East West Rail Non-Statutory Consultation – Winter 2024/5

Clapham Parish Council Response

Loss of Strategic Gap between Clapham and Bedford

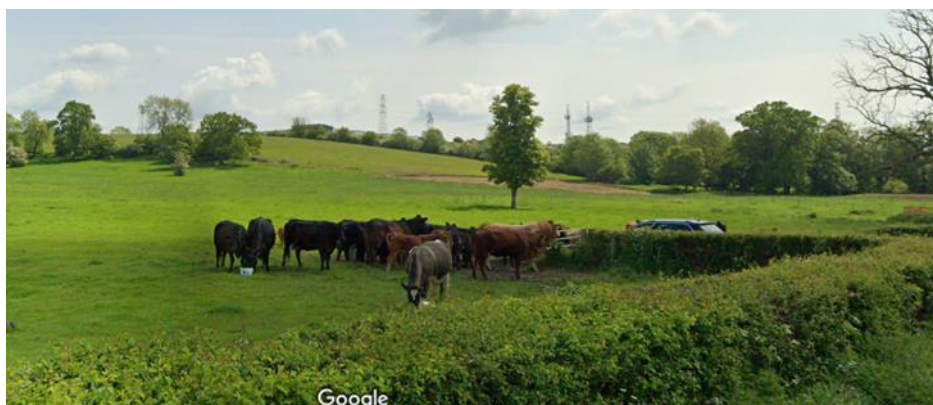
- The escarpment is a unique feature of Clapham with the village nestling at its toe. The alignment of the ridge is shown on the following contour plan

As the plan shows the ridge extends to the east of Clapham and through Bedford and forms part of a local historic landscape. Over the generations the ridge has been partly obscured by the expansion of Bedford, and development of the Manton Lane area. The development of the Spar Distribution Centre and Greenacres School along Manton Lane has continued this encroachment and now creates a prominent feature on the ridge creating a visual impact for many miles and to some extent has a negative impact of the nature and character of the land between Clapham and Bedford.

- Whilst not of national importance the ridge and this section of landscape has local context (NCA Profile: 88) and is a prominent aspect of the remaining landscape between Bedford and Clapham. CPC consider it is an important aspect of the nature and character of the village and its setting will be further inundated by the proposed viaduct,

embankment and cutting. CPC consider that this is unacceptable, and serious consideration should be given to placing the railway corridor into a tunnel to reduce the impact of the infrastructure.

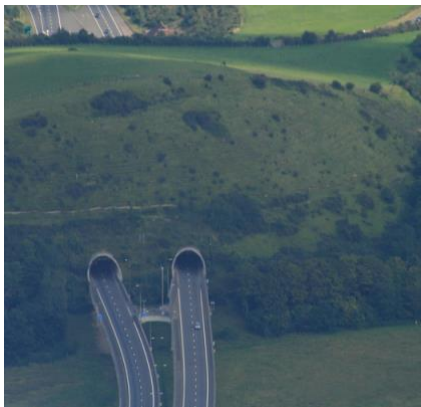
It is therefore very disappointing that a tunnel option has been dismissed for the section between Clapham and Bedford, and it is CPC's view a tunnel should be provided instead of a cutting. As noted elsewhere in this response, a tunnel would remove the impacts of the development proposals on:

- The pictures below shows the A20 tunnel at Folkestone in Kent and illustrates how a tunnel can significantly reduce the impact on the landscape. Together with an aesthetic design, this may provide a suitable solution to consider
